Large diameter NFPA compliant inlet valve designed to fit behind the panel becoming an integral part of the fire pump

# New position switches replace microswitches

#### Body with easy access grease ports

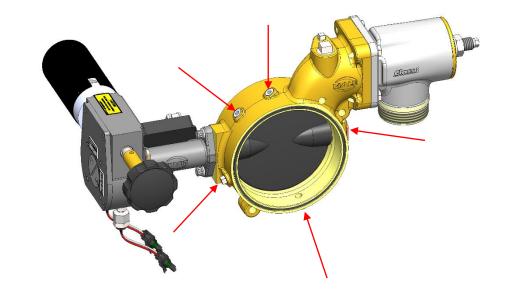
- 5 additional ports accessed around the MIV body
- Uses spray grease for maintenance
  - Super Lube Food Grade NLGI 2 Synthetic PTFE (Provided) (Aerosol 31040 & 31110 Allowed)
  - Can still use Sunoco Ultra Prestige 2EP grease or standard green grease

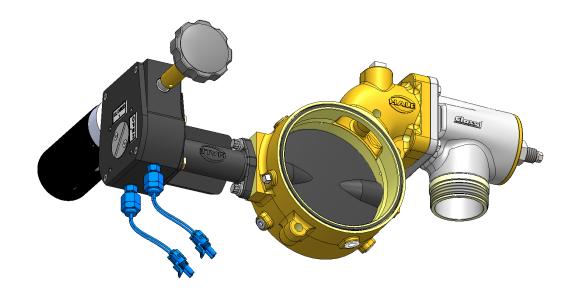
- Design utilizes standard switch used in gearboxes and Hale electric valves (Shown in blue)
- Robust design
- Easily adjusted
- Plumbing design must allocate additional space for larger switches

Valve to gearbox adapter offers more protection against water intrusion

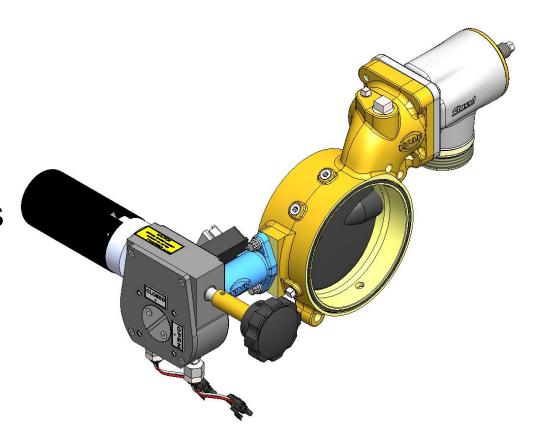
- Holes removed for microswitch connection
- Simplified design includes less parts for simpler maintenance

Panel offers a new integrated air bleeder with switch

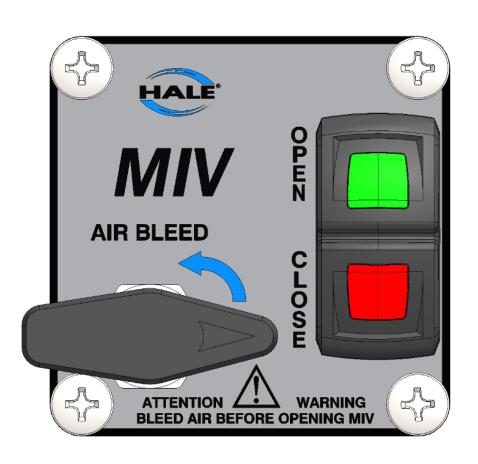
Reduces the used panel space

- Lighted switch
  - Green Open
  - Red Closed

#### New placards for manual MIV and Air Bleeder Valve

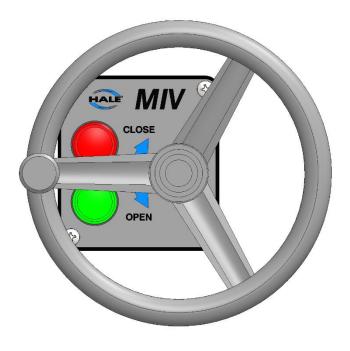
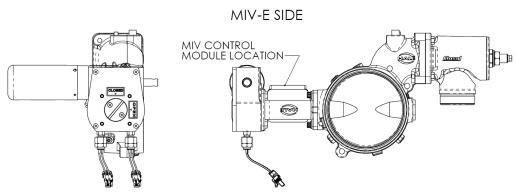
- Assemblies will be priced identically to legacy MIVs
- New part numbers will be needed when ordering MIV 2.0 (See FSG-PL-01491 for more information on the different
